As-Built by  
Paul Greenwalt

SL6746

**NORTHEAST TRI-COUNTY HEALTH DISTRICT**  
 Division of Environmental Health

Permit No. 8366

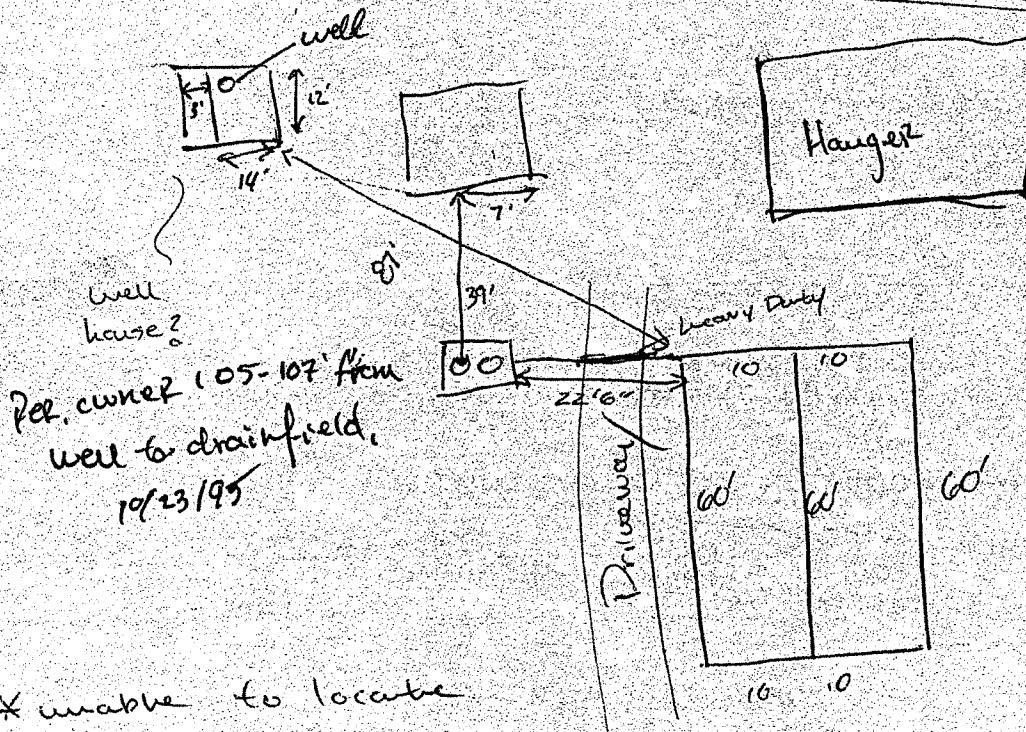
\* unable to locate well - PDG

10/18/95 - spoke w/ installer to determine well location. Randy Long said the owner told him the well was 110' from Drainfield. Left message w/ Randy Long to have home owner call our office and discuss. ~~Page~~ Bob House called and discussed well location w/ me. He said the well is located in the far N.E. corner of the well house and is approx 105-107' away from the Drainfield. For discussion w/ Charles Knight to approve based on Bob House's information. PDG
